2CAN012403

Subject: Supplemental Information - Adopt Risk-Informed Completion Times
TSTF-505, Revision 2, "Provide Risk-Informed Extended Completion
Times - RITSTF Initiative 4"

Arkansas Nuclear One – Unit 2
NRC Docket No. 50-368
Renewed Facility Operating License No. NPF-6

Responses to NRC Audit Questions

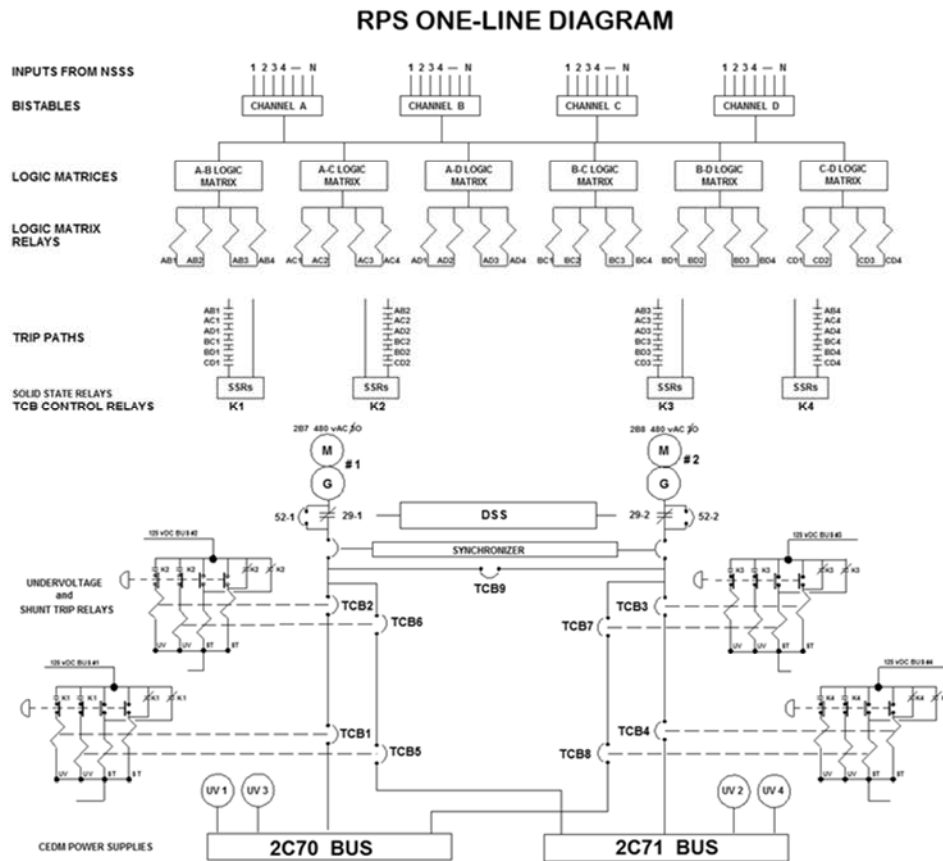
- b Supplemental) The audit portal response states, in part that, "... it is suggested the surrogate is revised to reduce one train of the modeled NSSS inputs ..." This description is not clear to the NRC staff. The staff believe the licensee is saying is that

all of the signal inputs to one input channel are set to trip so that essentially one (out of four) input channel is set to trip. The staff recalls from the audit that the ANO-2 PRA RPS model only models the input signals, the trip initiation circuits, and the trip logic. The staff would like confirmation that its understanding of the licensee's statement is correct and, if so, for the licensee to consider revising its statement above to be in line with this more standard language when describing their surrogate.

If the NRC staff's understanding is not correct, then additional discussion will be necessary for full understanding.

a.ii) Due to the multiple redundancies, the PRA does not model the RPS system's matrices and their associated outputs. It is noted that the surrogate applied assumes all matrices are available. However, as stated in the response to a.i, the RPS system only has one TCB SSR remaining to de-energize the TCB for use to trip the reactor. Note, there is still the manual scram and redundant diverse scram system (DSS) system.

This configuration is a conservative surrogate because two matrices can provide a signal to all four TCB SSRs. The surrogate has one less TCB SSR, and less trip paths than if two matrices were modeled.

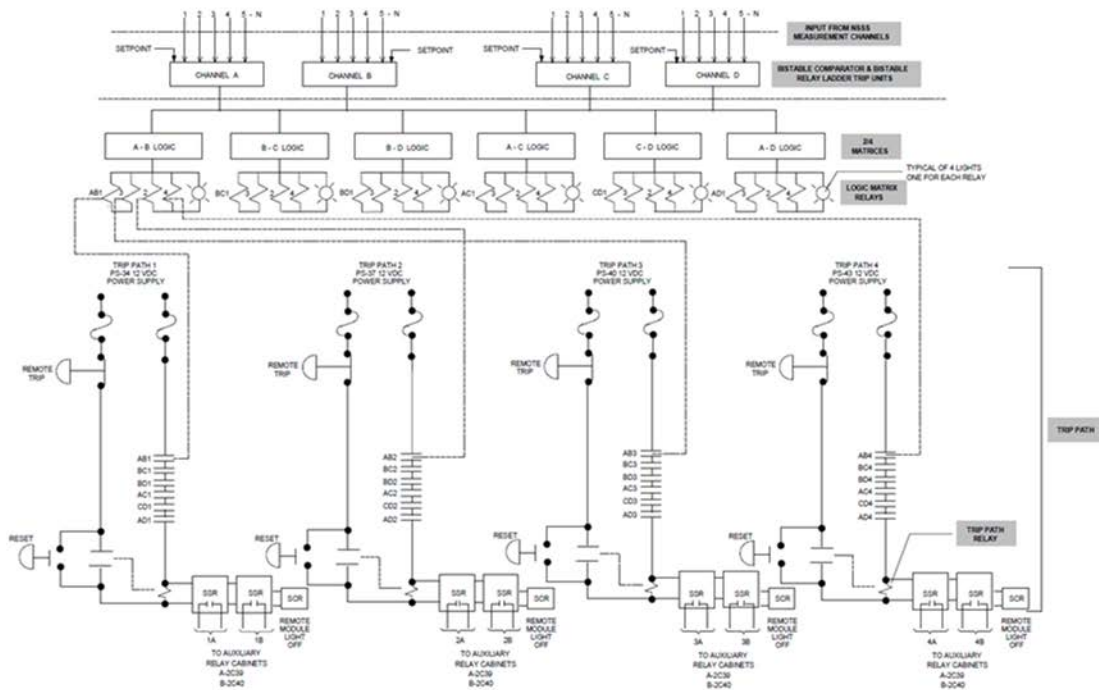
- b Supplemental) Using the RPS one-line diagram above, the CEACs provide a digital input from NSS to each of the four bistables (channels A,B,C, and D). The CEACs are conservatively not credited as an input into the RPS system in the PRA. However, four sets of analog inputs to each bistable channel are included in the RPS system in the PRA. The surrogate would identify a limiting analog input and fail/reduce the number of inputs to each of the four bistable channels from four inputs down to three inputs to each channel. Using the diagram above, with NSS inputs 1,2,3, and 4 being modeled in the PRA, the surrogate would reduce the inputs by one train. In other words, assuming input 4 is the surrogate, the PRA would fail inputs 4 into A, 4 into B, 4 into C, and 4 into D. The PRA calculations would estimate the risk associated with the degraded RPS system and the loss of its redundant input.

The staff is correct. Using the diagram above, the inputs/bistables, and the trip control relays are modeled. The logic Matrices and Matrix relays are not.

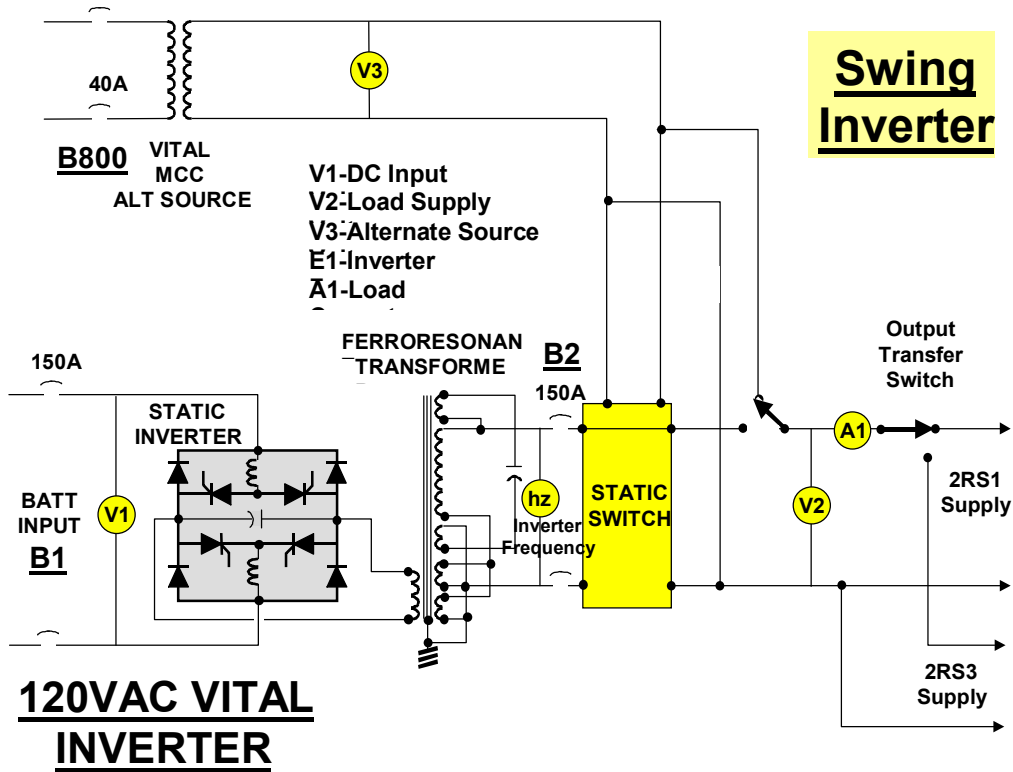
GDC 17 requires, in part, that both offsite and onsite electrical power systems be provided to permit functioning of SSCs important to safety. The safety function for each system, assuming the other is not functioning, shall be to assure that fuel design limits and design conditions of the reactor coolant pressure boundary are not exceeded, the core is cooled, and containment integrity and other vital functions are maintained in the event of postulated accidents. This includes the onsite 120-Volt Uninterruptable AC Power System.

ANO-2 SAR Section 8.3.1.1.6 indicates that there are six inverters and four distribution panels in 120-Volt Uninterruptable AC Power System. System Training Manual 2-32-4, Section 2.2.1 indicates that there are red and green swing inverters with each employed if either one of the two normal inverters it supports is inoperable. The diagram in Section 2.2.2 is for a swing inverter.

If the incoming breaker for the static switch, as shown in diagram System Training Manual 2-32-4, Section 2.2.2, should fail, is there an alarm to indicate that failure in the main control room?
